*Svenska Aeroplan Aktieföretaget*

# service bulletin

No. 91. 1. 001

**AIRCRAFT SAAB SAFIR 91A, 91B, 91B-2 AND 91C.**

Figure 1

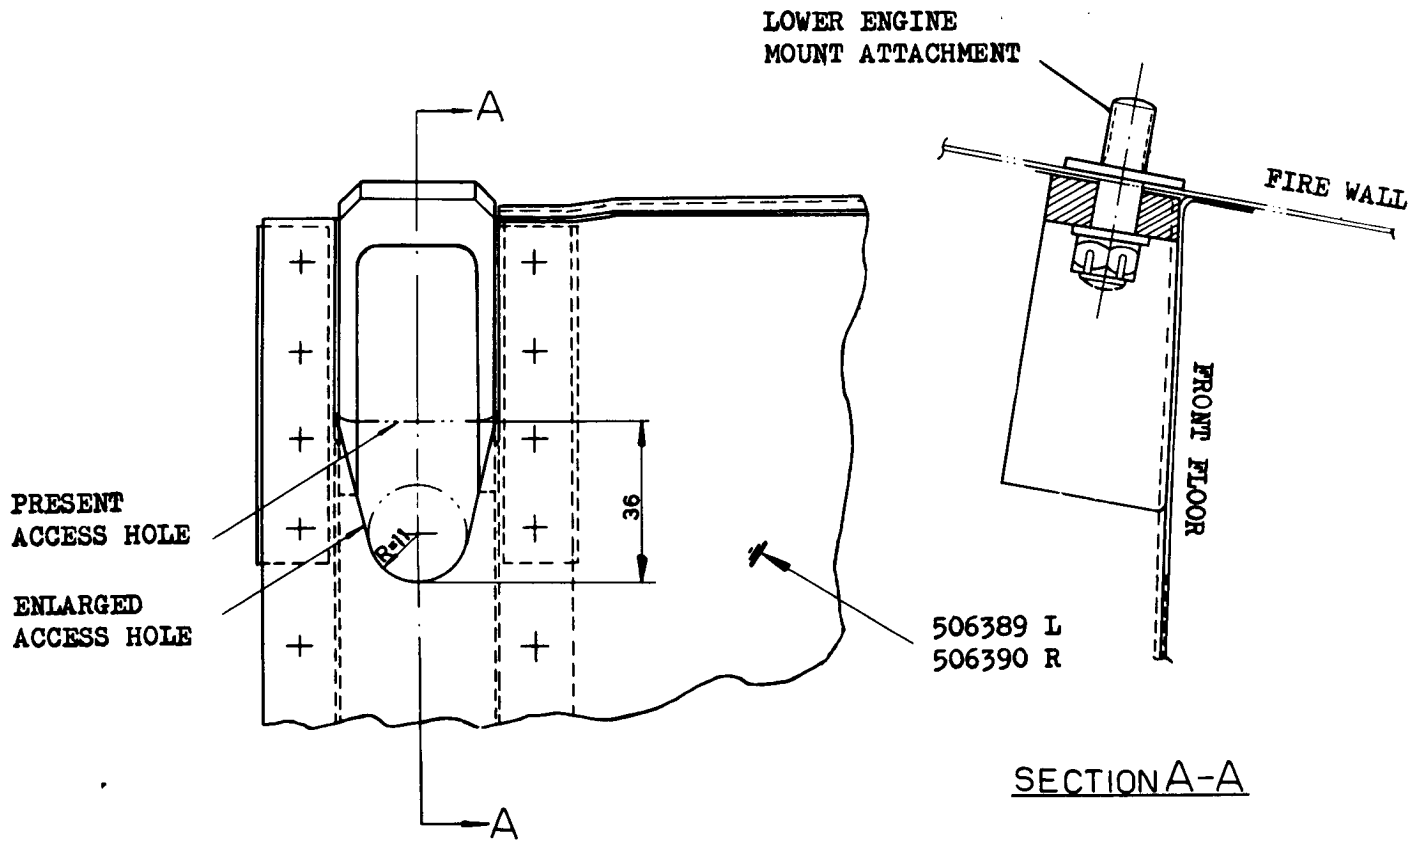
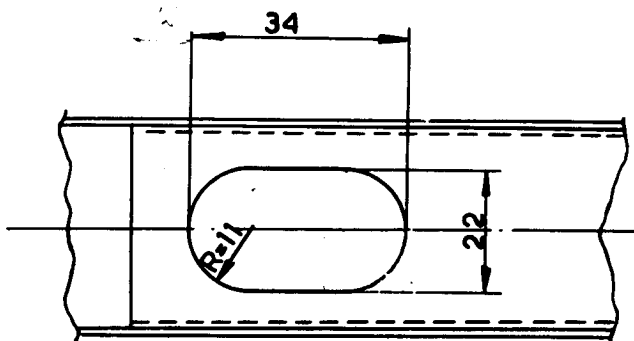
Enlarge the holes in the LH and RH front floor panel above the brackets for the engine mount bolts according to fig. 1.

Figure 2

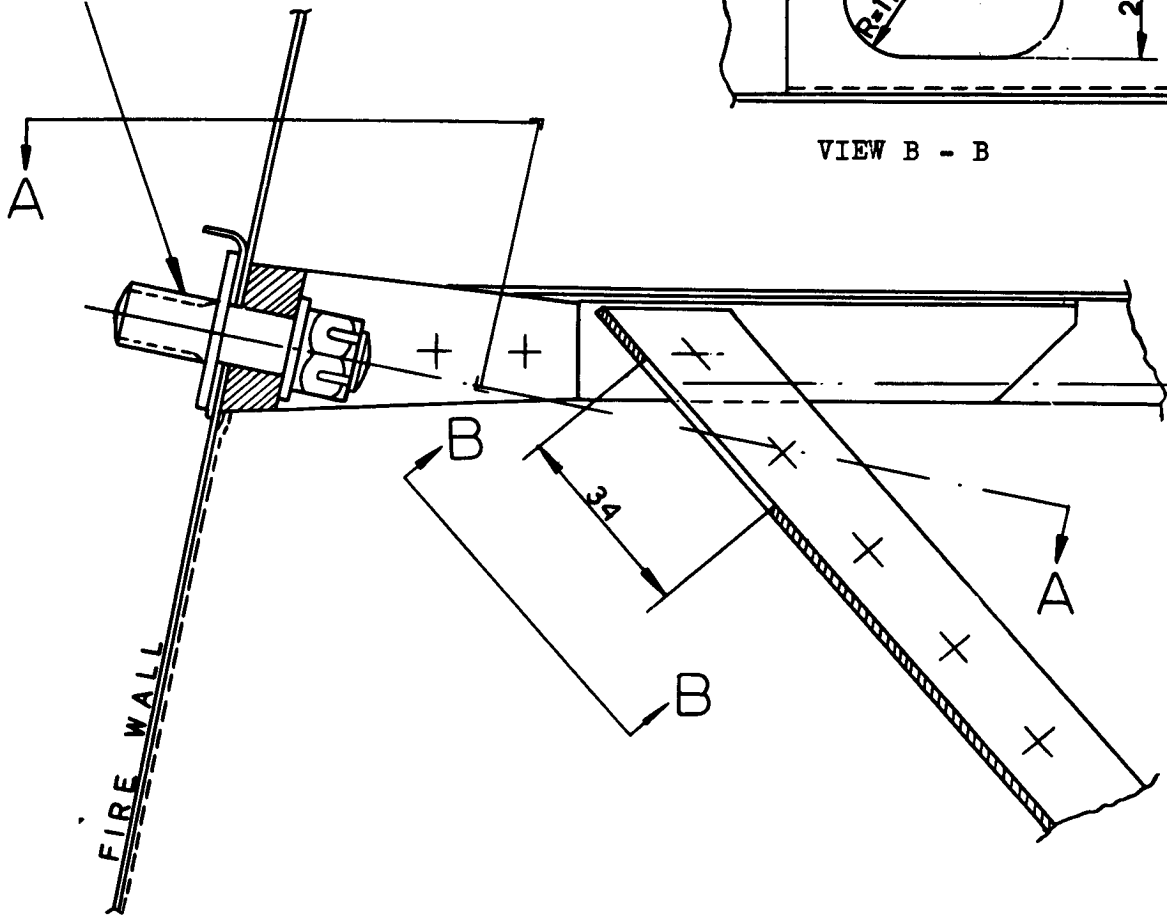
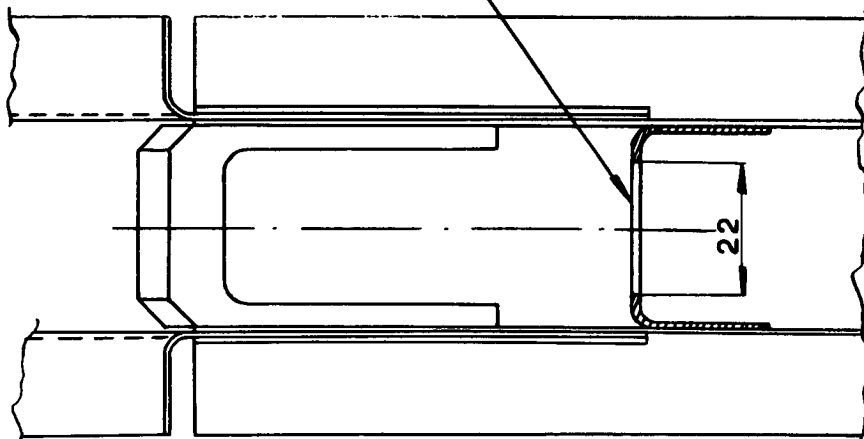
Cut out holes in the front section of the LH and RH pedal support according to fig. 2.
